ARTICLE 430 — MOTORS, MOTOR CIRCUITS, AND CONTROLLERS

11-8a Log #1 NEC-P11 **Final Action: Accept in Principle**
(430)

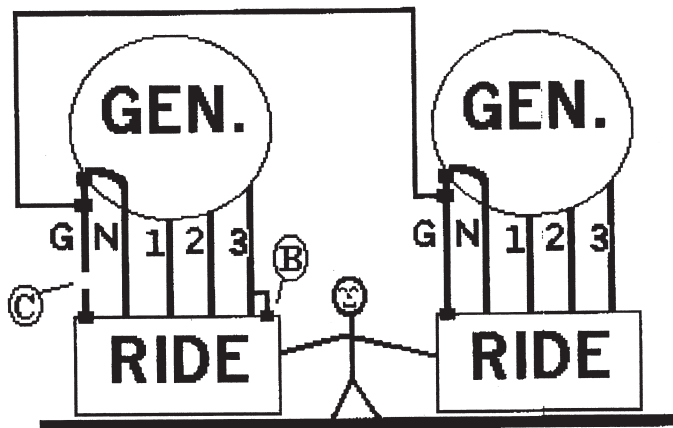
This is an attempt to show why having the grounds of multiple generators interconnected will result in an unsafe electrical condition in the carnival environment.

Following is a drawing which shows two rides, each being supplied by a different generator, being touched by the person between them. On the right side, the ride is correctly bonded back to it's generator. Both generators have the "grounded" and "grounding" conductors bonded together correctly. On the left side the "grounding conductor" is open at "C". Also, on the left side there is a fault at "B" where phase 3 touches the frame of the ride.

There will be an electrical path from phase three of the generator on the left side - to the left ride which has the fault - through the person touching both rides - to the ride on the right - thru the right ride's "grounding" conductor (green) - to the generator which supplies power to the right ride - thru the bonding conductor between generators - back to the original generator, on the left side.

Not having the "grounding conductors" of multiple generators "bonded", would leave this path for electrical current open. Thereby, eliminating the potential for electrical shocks.
